# DESIGN REVIEW BOARD

**DRB21-00119**

Requesting the review of a drive-thru coffee shop.

# Landscape Plan

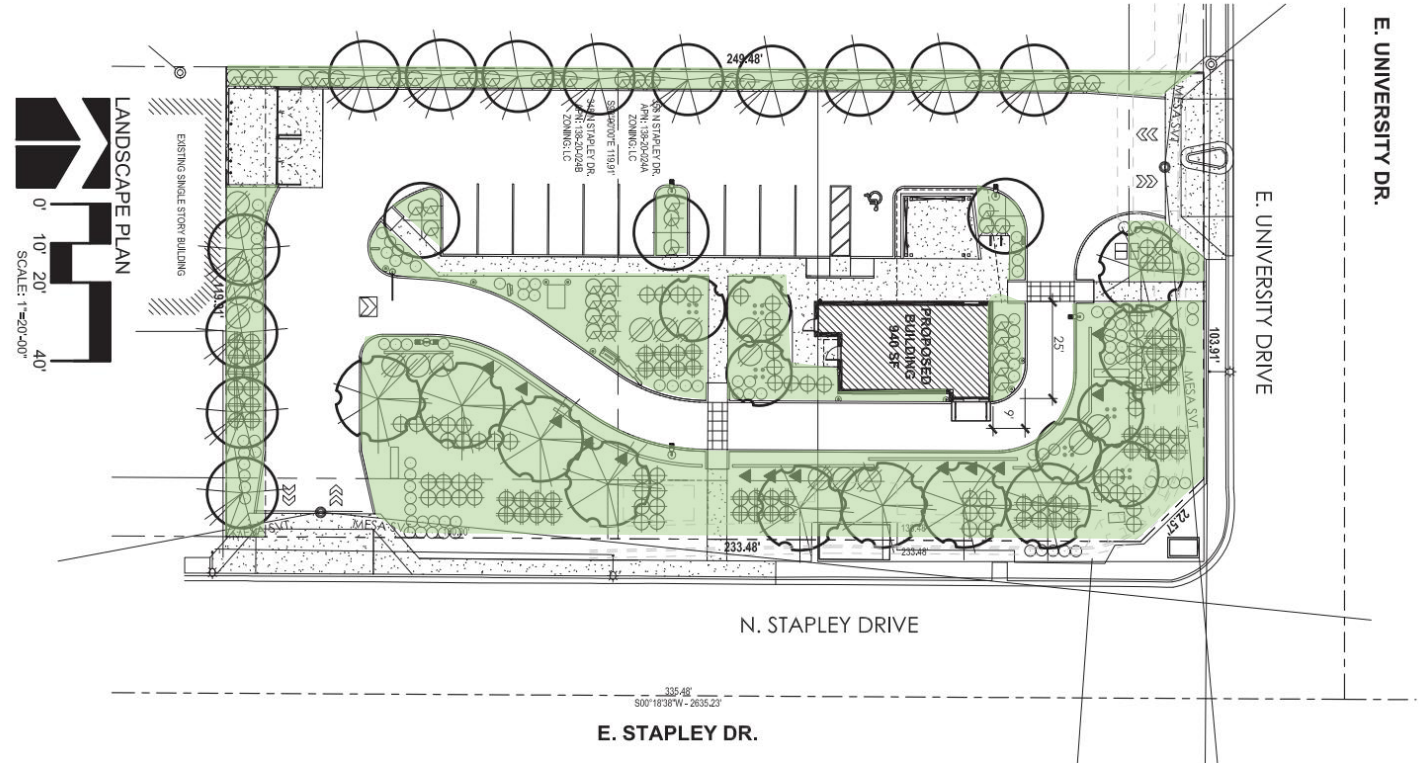
- 5-foot landscape buffer along western property line
- 10-foot landscape buffer along southern property line
- Ample landscaping between parking stalls and drive-thru lane

# Elevations

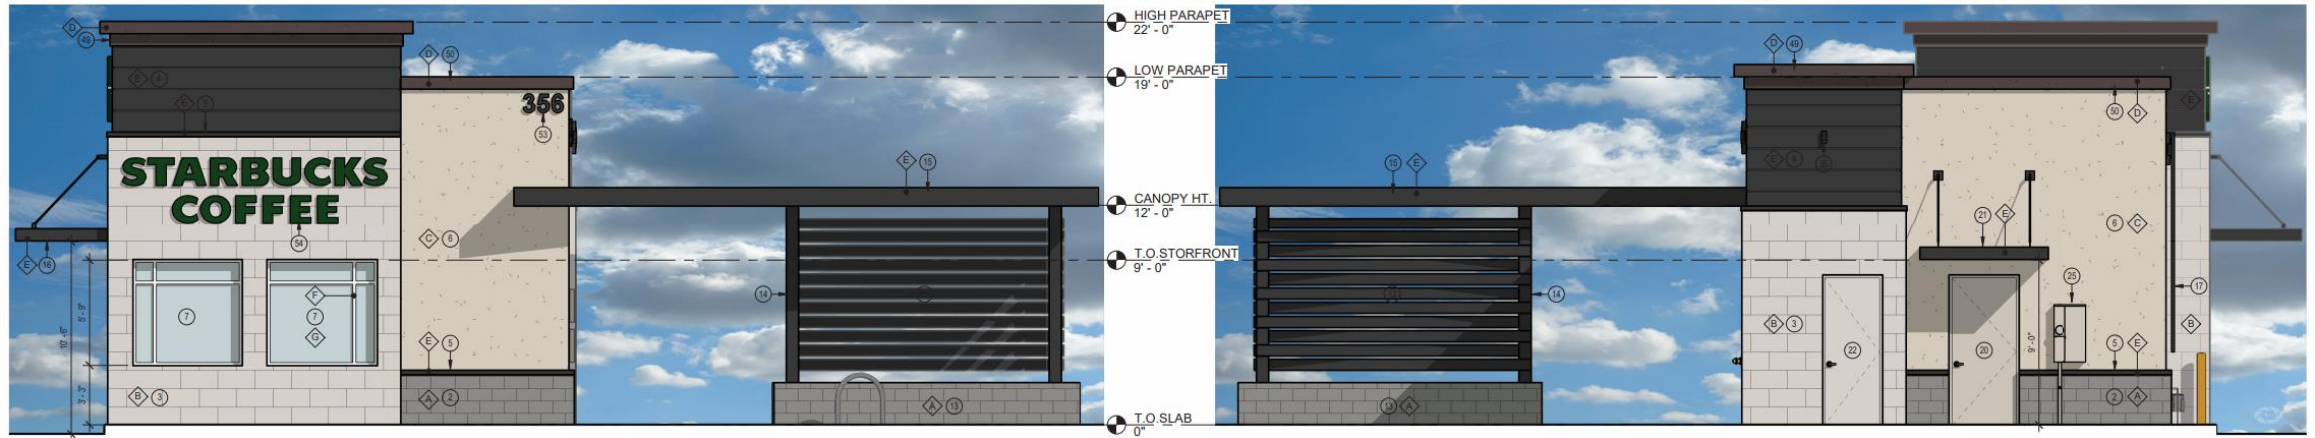
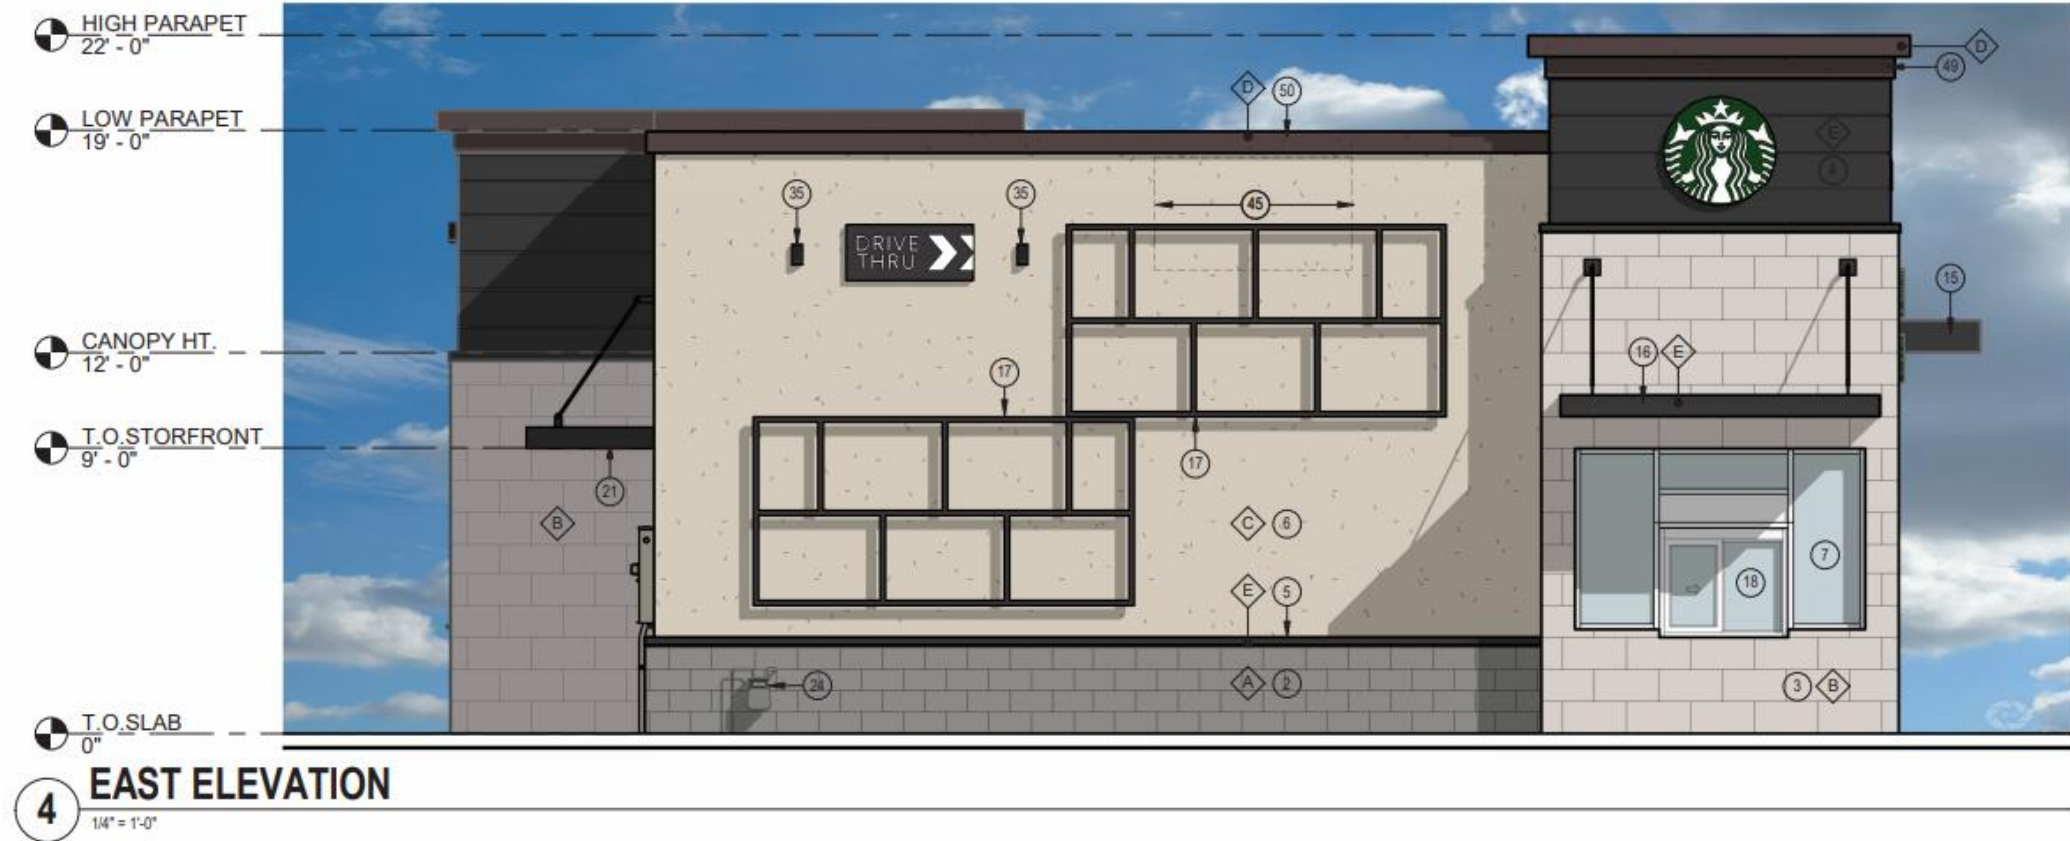
- ✓ Design incorporates multiple materials
  - ✓ Exterior walls are subdivided using projections, overhangs, and awnings
  - ✓ Design provides architectural interest along the roofline
  - ✓ No more than 50% of each façade is covered with a single material
- 
- Staff welcomes any feedback

# Lighting

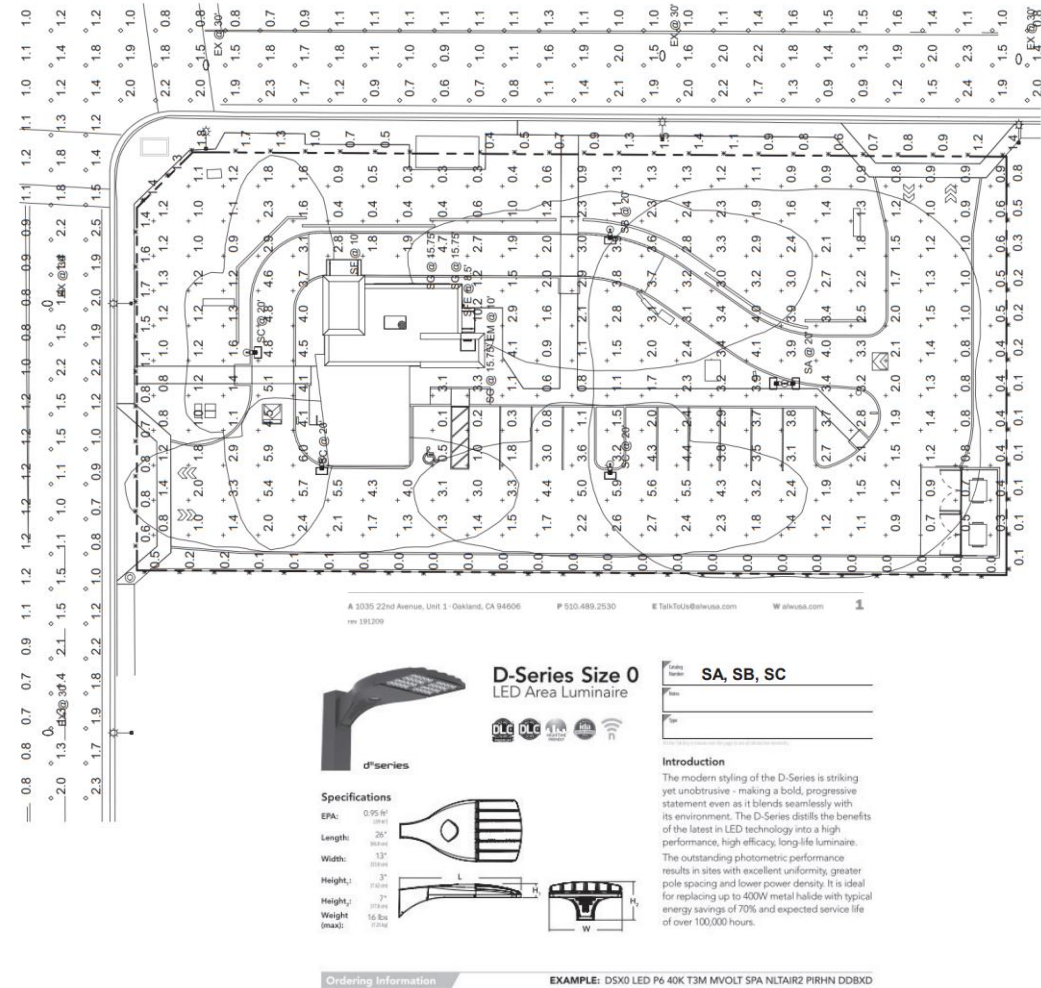
- Freestanding light poles do not exceed the maximum height specified in Table 11-30-5 in the MZO
- Building-mounted lights use shielded, directional fixtures
- Spillage does not exceed 0.5 foot candles above ambient levels along the western property line
